## Product Change Notification

**1. ECR #:** 162158  
**Notification #:** 318

**3. Series:**  
• MMCX7 - 75 OHM JACK AND PLUG

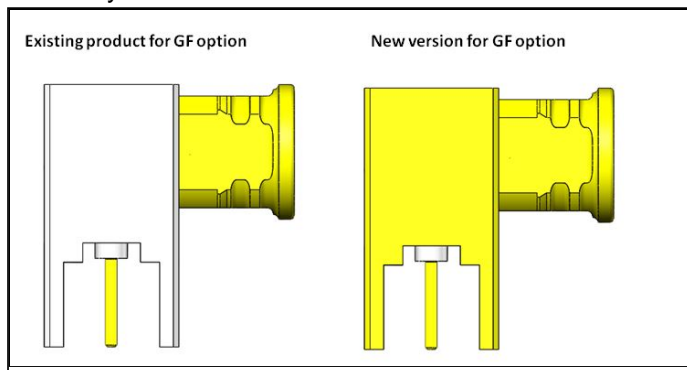
**5. Description of Change:**  
The plating on the body will change from 100u" Nickel to 3u" flash Gold.

**7. Reason for Change:**  
The shell and body is being changed from a two -piece design to a one-piece design to improve product robustness.

**8. Impact of Change on Form, Fit, or Function:**  
• Form - For GF plating option, the plating on the body will change from Nickel to flash Gold.
